WOODRIDGE LODGE  
LOT 619, DP 1118588  
WOODRIDGE, THREDBO VILLAGE

ELEVATIONS 1

issue no: DA2

drawing no: DA20

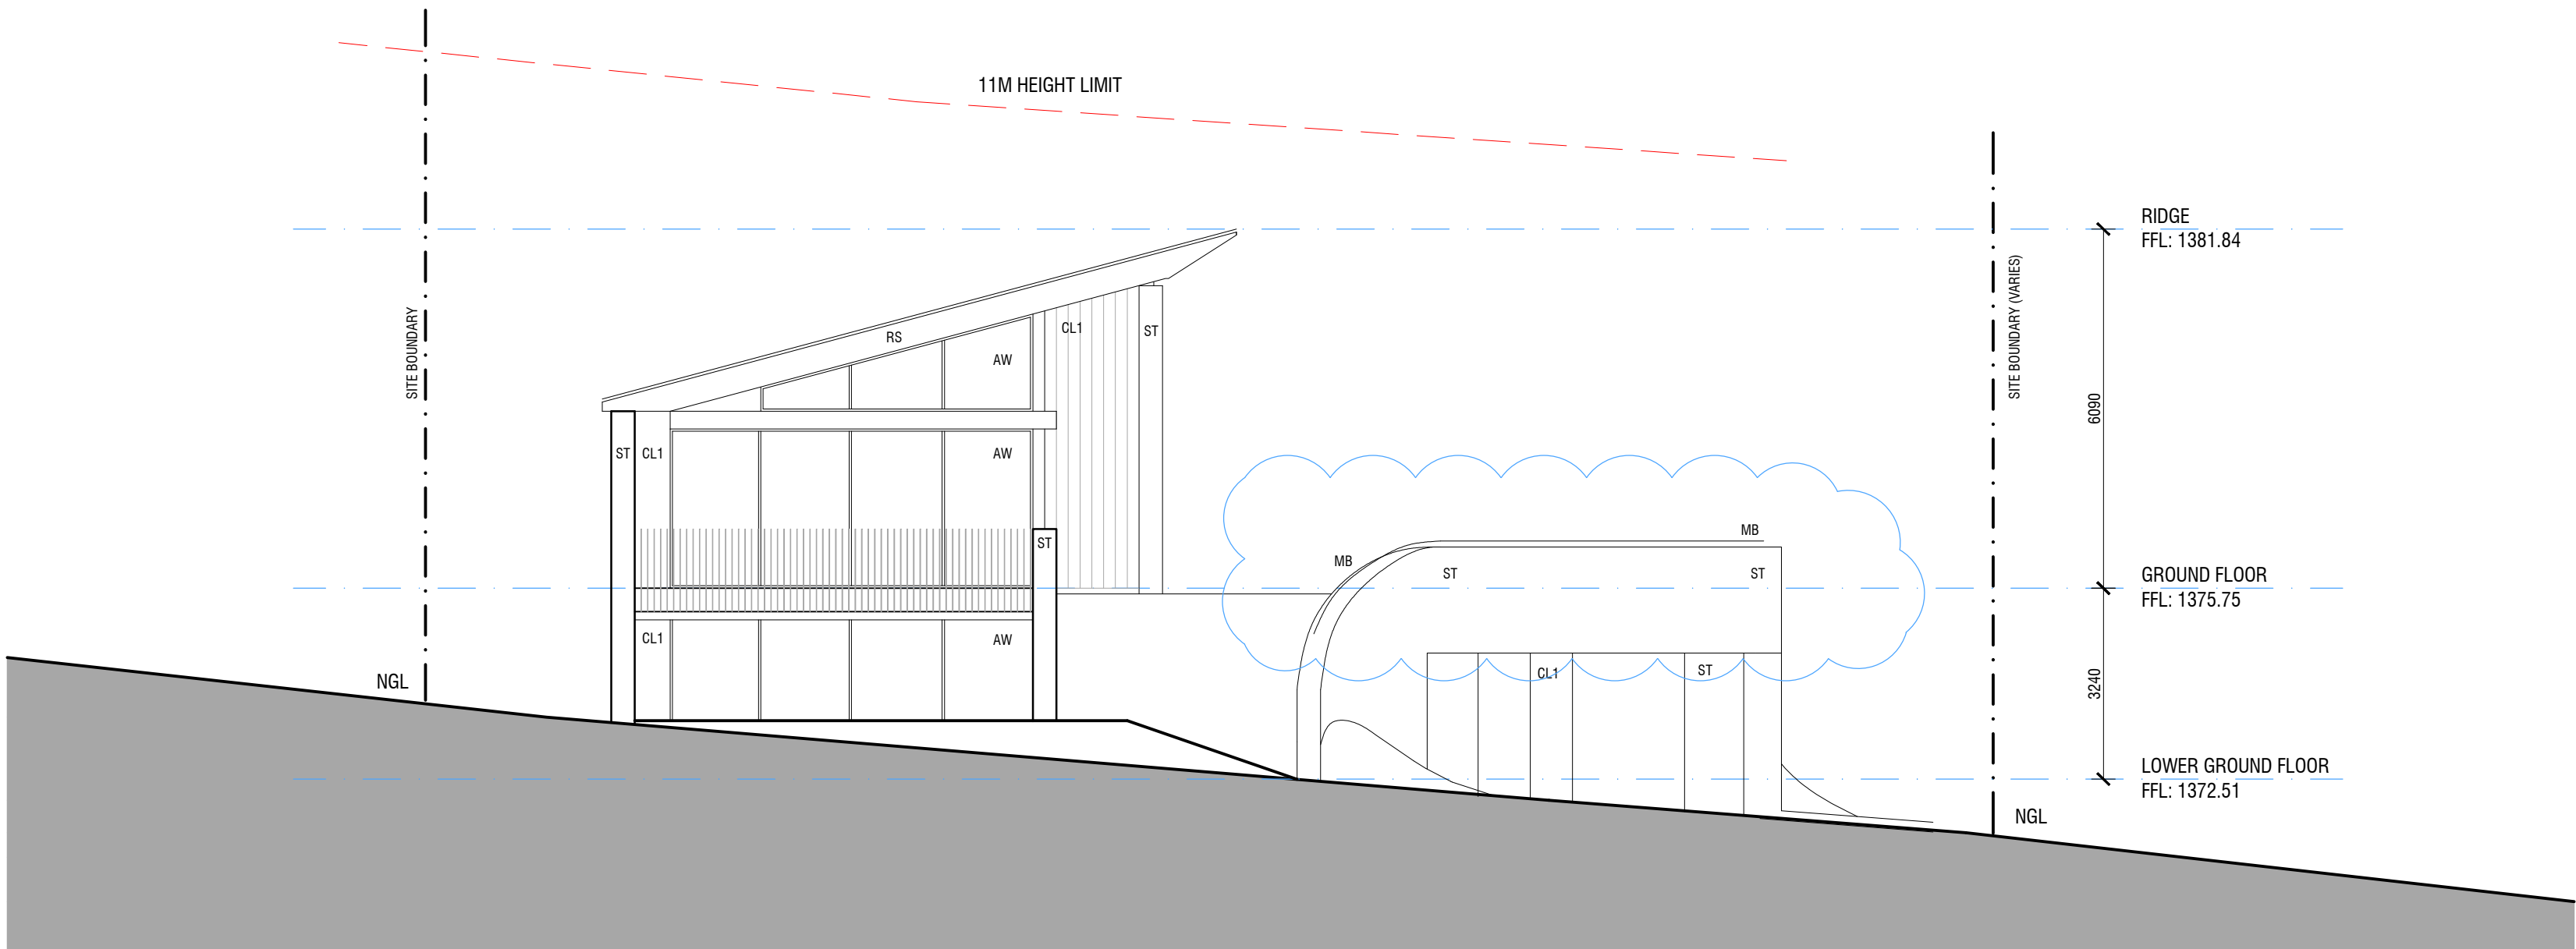
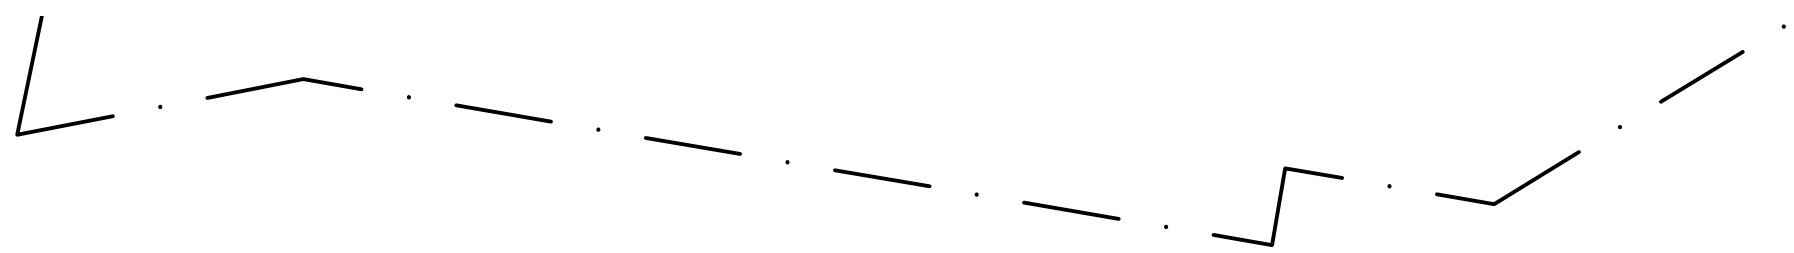
- ADDITION OF NOTES
- SILL OF LOWER GROUND WEST FACING WINDOWS LIFTED FOR SNOW SAFETY
- TERRACE BALUSTRADE LIFTED BY 200mm
